Re: **Addendum to the Highway 407 Transitway Corridor Assessment Within the Ninth Line Lands Study Area (Amec Foster Wheeler, 2016), City of Mississauga**

This memorandum is provided as an Addendum to the "Highway 407 Transitway Corridor Assessment Within the Ninth Line Lands Study", completed by Amec Foster Wheeler (now Wood) for the City of Mississauga in October 2016. The need for this addendum has been largely driven by concerns raised by Conservation Halton (CH) with respect to the originally-proposed use of a Flood Protection Landform (FPL) to protect existing and future land north of Britannia Road, as well as concerns related to the need for a wider watercourse meander belt width and maintenance access north of Derry Road. The approaches to addressing CH concerns are summarized in the following subsections, which deal specifically with the Transitway segments to which they apply (namely Segment 3 for the FPL and Segment 5 for provision of additional meander belt width). The limits of the Transitway segments as defined under the 2016 Transitway Corridor Assessment Study are as defined and illustrated in Table 1.

Figure 1: Cross-Section Through Segment 3 with Cut /Fill Balance.

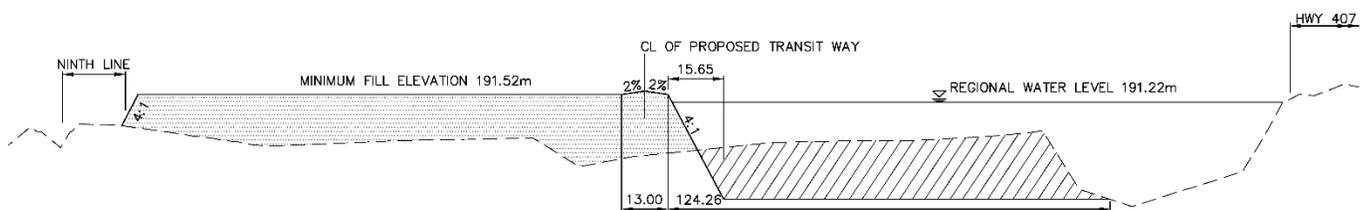
Since completion of the *Highway 407 Transitway Corridor Assessment* in 2016, Conservation Halton and MNR have indicated that they do not formally support the use of "Flood Protection Land Forms (FPL)" in the Ninth Line Lands setting to provide permanent flood protection for land abutting the regulated watercourse. As a result, the recommended approach to modifying the Regulatory Limit through Segment 3 of the study corridor has been revised, and the more traditional approach of watercourse corridor realignment and strategic cut/fill balance is being recommended. Under this scenario, the Transitway embankments will serve as the east limit of the watercourse corridor and the land east of the Transitway will be filled to a minimum of 0.3 m above the Regional Storm flood depth, effectively removing it from the Regulatory floodplain. The design criteria to be adhered to when completing the grading design for the cut/fill balance are summarized in Table 1, and illustrated in Figure 1.

**Table 2: Design Criteria for Land east of the Transitway, north of Britannia.**

Design Criteria	Recommended Value
Minimum Fill Elevation	191.53 m (0.3 m above Regional Storm Flood Level)
Development Restrictions	None
Site Servicing Restrictions	None
Recommended Fill Material Specifications	Engineered Structural Fill

Figure No. 2

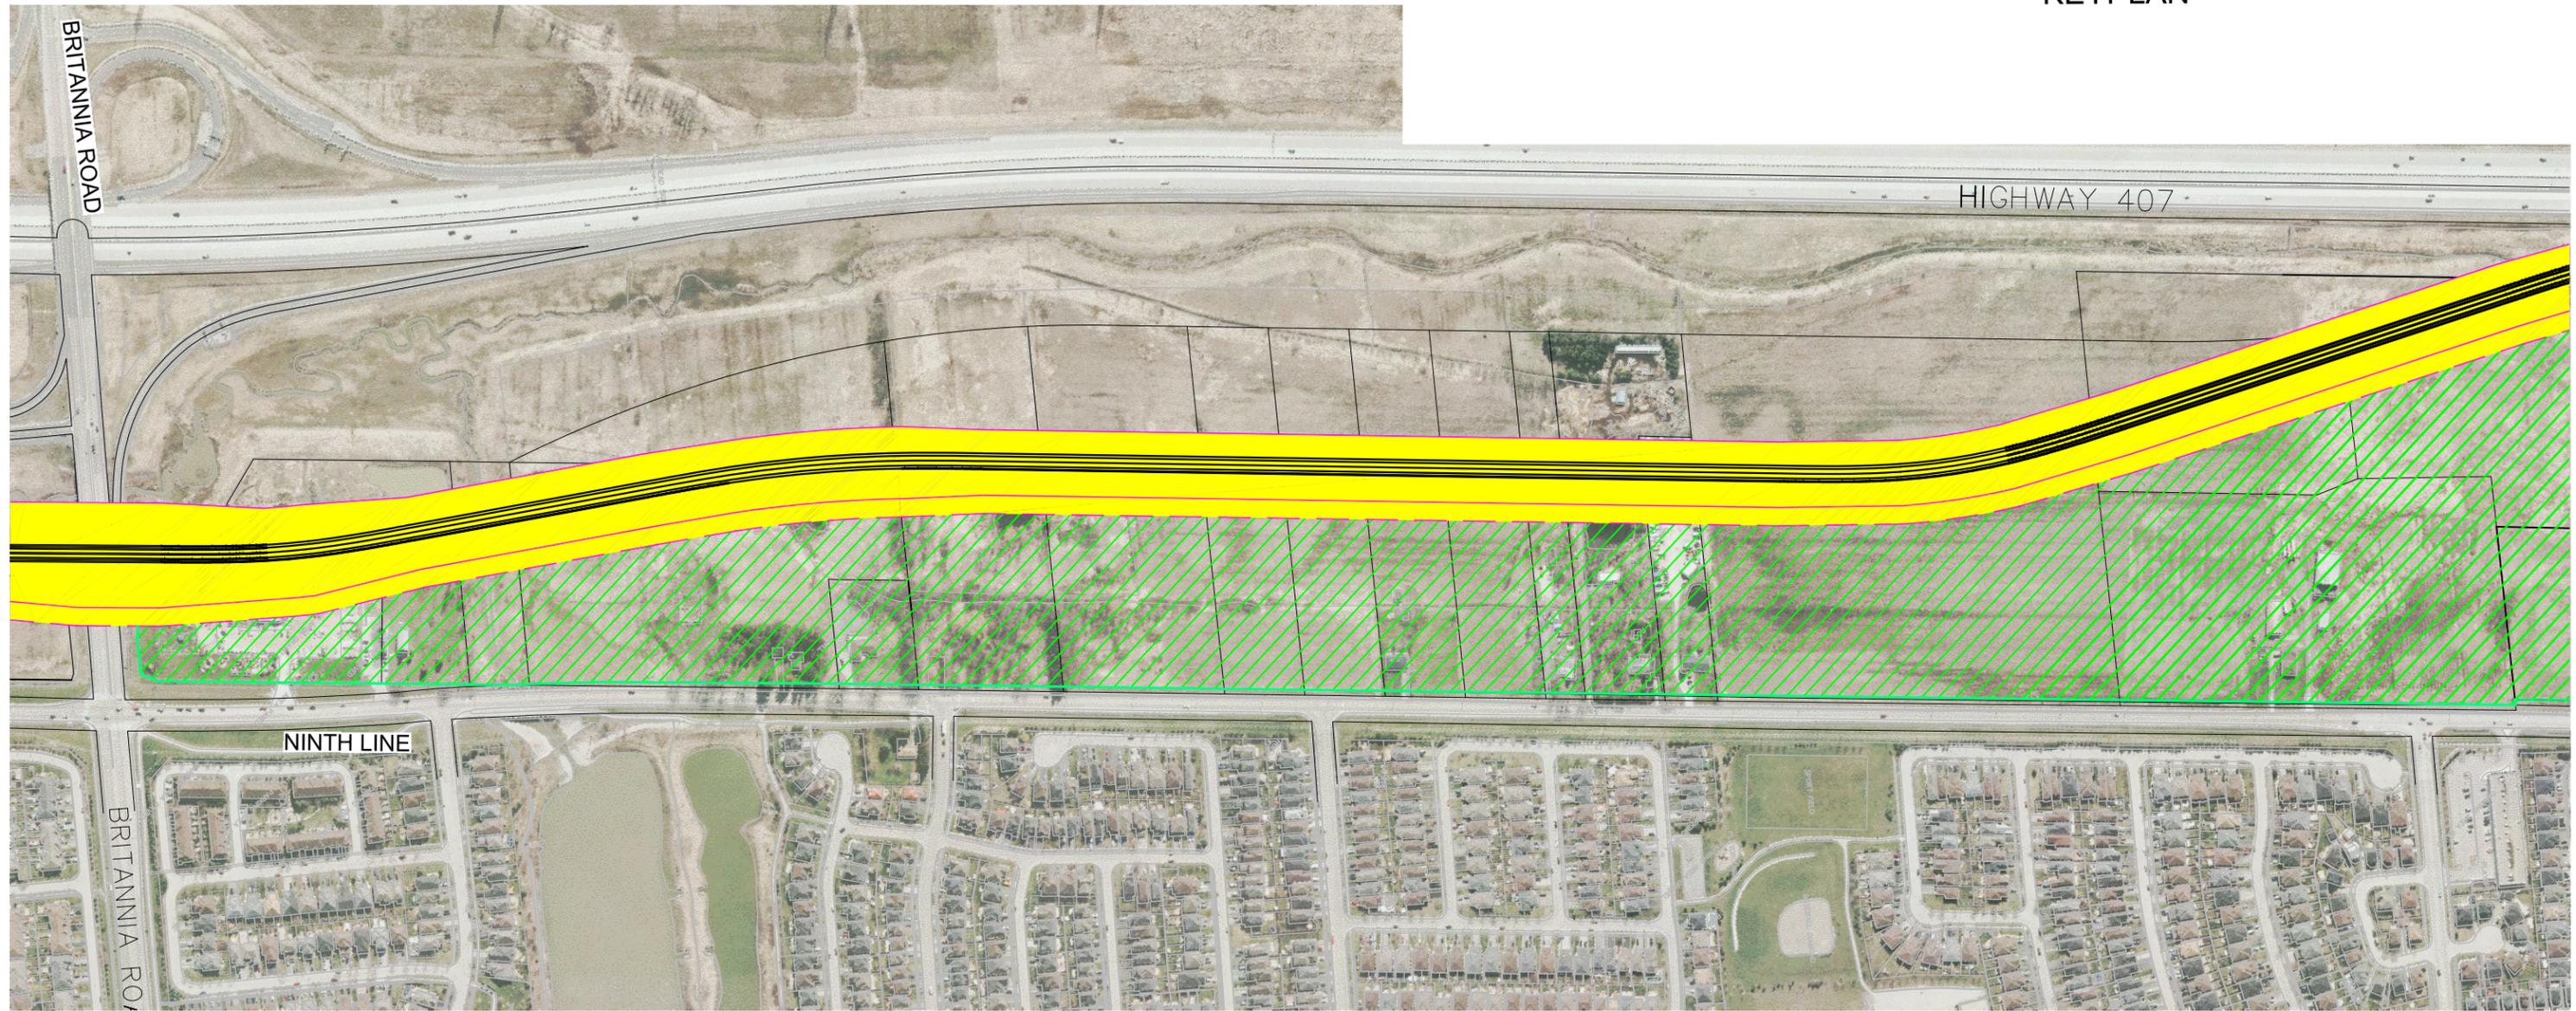
Under the updated strategy, approximately 27 ha (+/-) of land would be removed from the Regulatory Floodplain and made available for unrestricted development. Updates to the proposed Regional Storm Floodplain Mapping and associated change in restricted and unrestricted developable areas through this segment are illustrated in Figures 2 and 3<sup>a</sup>, at the end of the report.

Project No. **TP114008**  
 Scale HOR.  
 VER.  
 Figure No. **4**

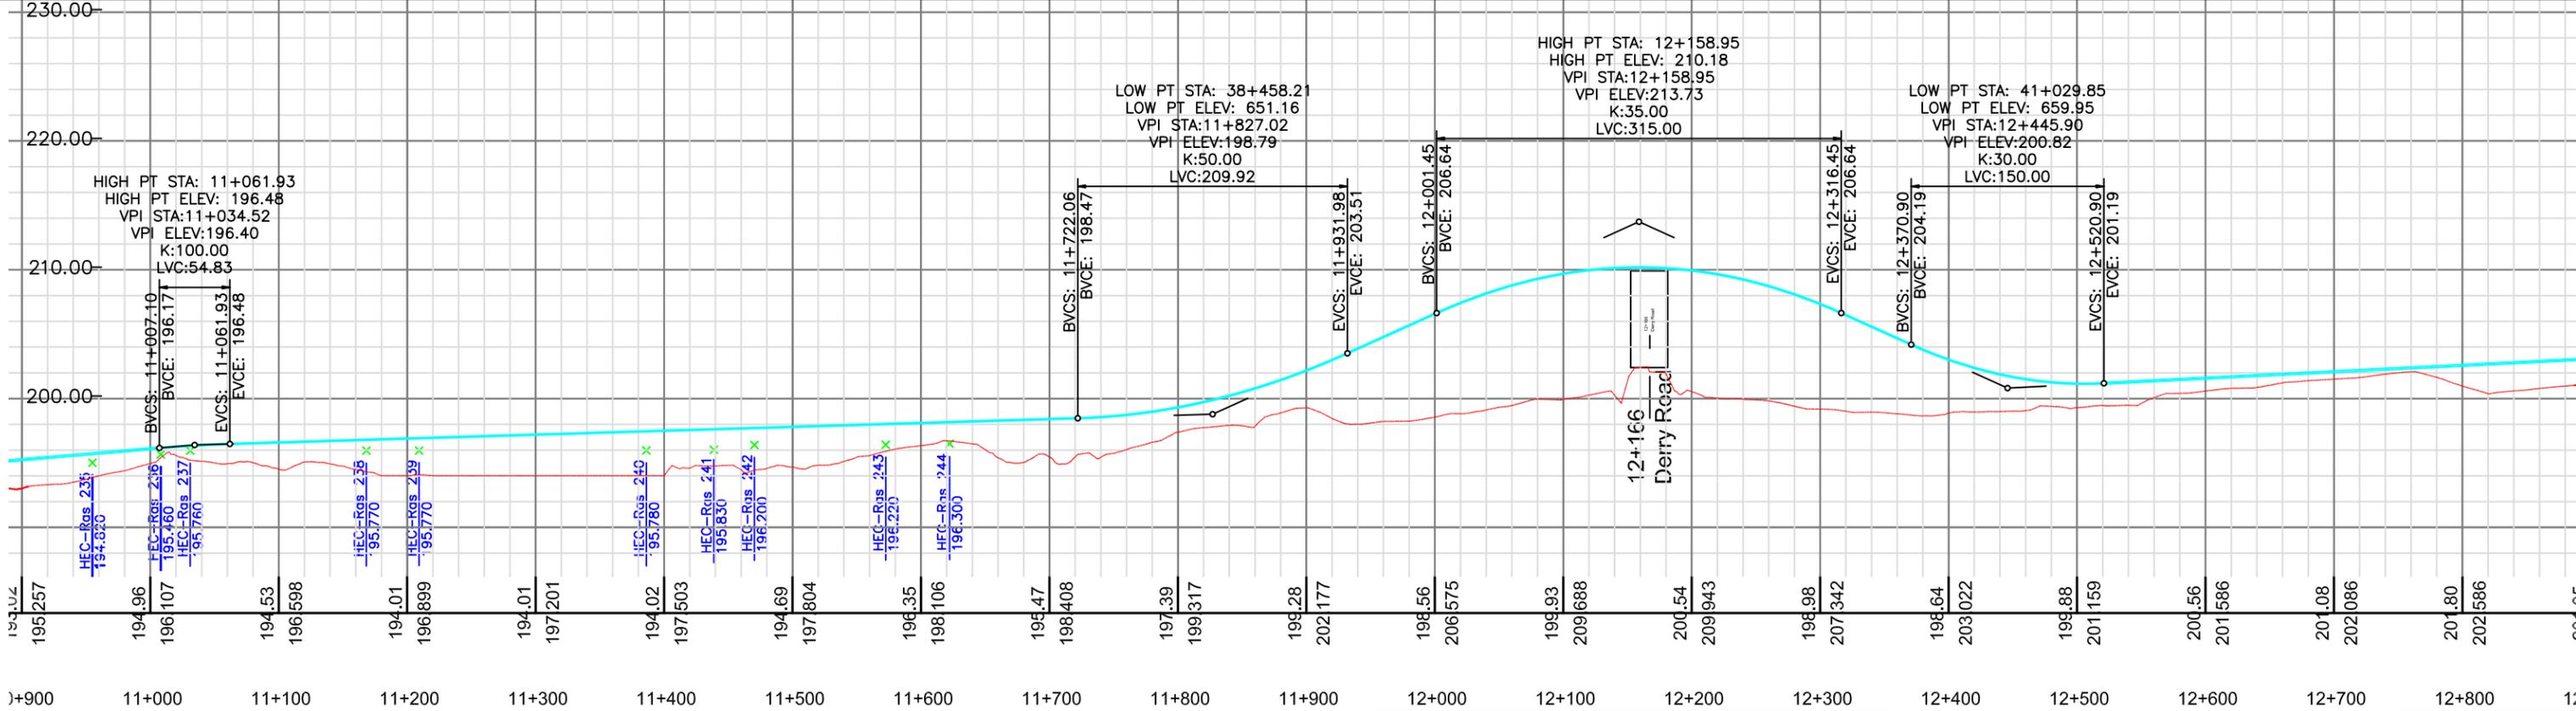
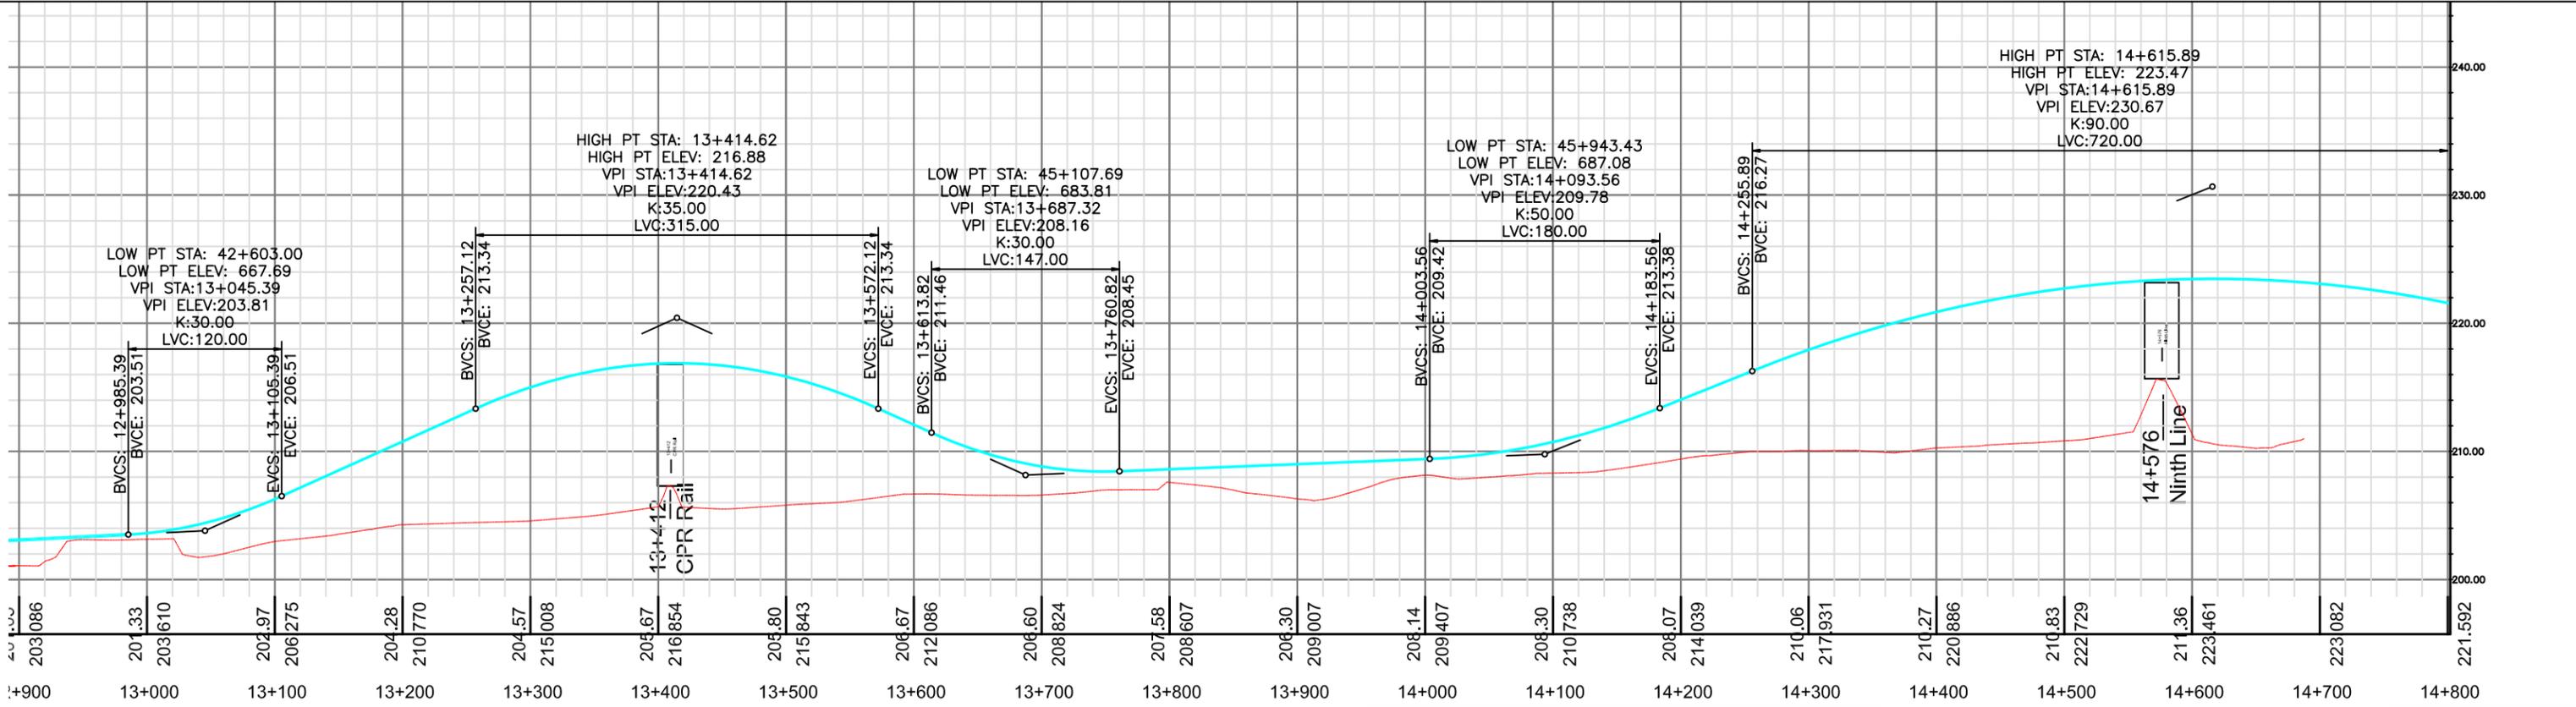
from the limits of Highway 407. Additional setback was provided through the segment adjacent to the Derry Road interchange, and the segment north of the CP Rail crossing, for which an ~100 m corridor was provided to address clearance around existing Hydro One towers. Based on further review by Amec Foster Wheeler and CH, it was determined that the 70 m wide flood plain, provided between Highway 407 and the future Transitway, was insufficient to accommodate the identified meander belt width in this reach, as well as maintenance access for the realigned channel. As a result, the originally-proposed Transitway alignment will require a further easterly shift along the length of Segment 5, with the westerly limit of the Transitway now approximately defined by meander belt width, the floodplain valley slope, and the 15 m CH Regulatory Setback, a portion of which is on the Transitway lands. In addition to providing additional corridor width for future meander of the creek, the easterly realignment of the Transitway will provide additional land for the overall Ninth Line Community Natural Heritage System (NHS).

The revised Transitway plan and profile through Segment 5 are illustrated in attached Figure 4 and Figure 5<sup>b</sup>, with associated updated right-of-way widths summarized in Table 2. The revised alignment is generally linear between Derry Road and the Highway 401/Highway interchange, with exception of a further easterly shift immediately north the CP Rail line, again to mitigate potential impacts to existing Hydro One transmission towers. As with the previous alignment, the Transitway design criteria are adhered to through this segment.

**Table 3: Revised Transitway Right-of-Way Limits Through Segment 5.**

Transitway Station Limits	Recommended Right-of-Way Width (m)	Corridor Width Left of Centerline (m)	Corridor Width Right of Centerline (m) <sup>c</sup>
12+300 to 12+380	80.0	36.0	44.0
12+380 to 12+500	59.0 – 80.0	23.0 – 36.0	36.0 – 44.0
12+500 to 13+040	59.0	23.0	36.0
13+040 to 13+160	59.0 0 -90.0	23.0 – 36.0	36.0 – 54.0
13+160 to 13+580	90.0	36.0	54.0
13+580 to 13+700	64.0 – 90.0	25.0 – 36.0	39.0 – 54.0
13+700 to 14+100	64.0	25.0	39.0
14+100 to 14+220	64.0 – 97.0	25.0 – 40.0	39.0 – 57.0
14+220 to 14+880	97.0	40.0	57.0
